TO: U.S. Environmental Protection Agency & ENERGYSTAR®

November 8, 2011

We are pleased to offer comments today in regard to the ENERGYSTAR® for Windows, Doors, and Skylights Version 6.0 Product Specification Framework Document dated October 2011. We offer these comments on behalf of Lifetime Windows & Doors, inc. in Portland, Oregon. We are an independent window and door sales and Installation Company as well as the developers of “Solar View” windows which are “Passive Solar” window assemblies designed for Heating Dominated Climates.

Phase 2: ES5

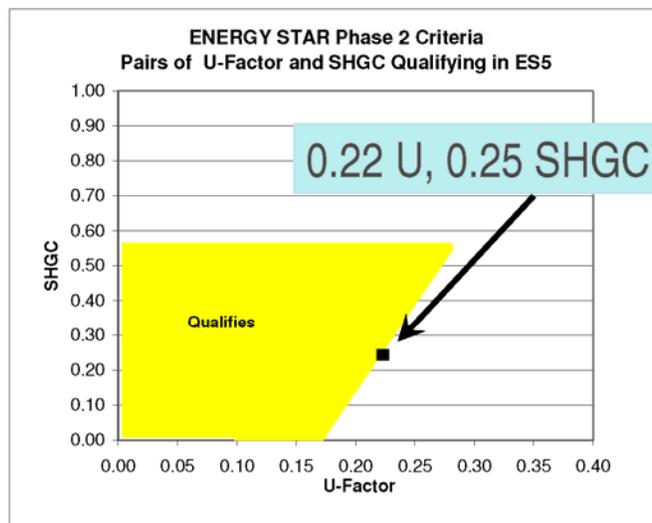
This chart below done for the first Draft Criteria released by the Department of Energy for the Northern Heating Zones is supposed to compare efficiencies of windows based on the Correlation between Solar Heat Gain and U-Factor.

According to this chart a window with a .18 U-factor and a SHGC of .05 performs in the Northern Climate Zone with the “energy equivalency” of another window with a U-factor of .28 when the SHGC is .55.

That is a spread of 10 U-factor points based SOLELY on the difference in Solar Heat Gain. By declining to include SHGC Trade-offs for Northern Climate Zones ENERGYSTAR® is failing to properly measure true energy performance of windows for Northern Climate Zones. By doing so ENERGYSTAR® is giving a free pass to Manufacturers to use more readily available dark Low-e coatings and simultaneously miss the opportunity to properly motivate future development by honoring and recognizing “*overall energy performance*”.
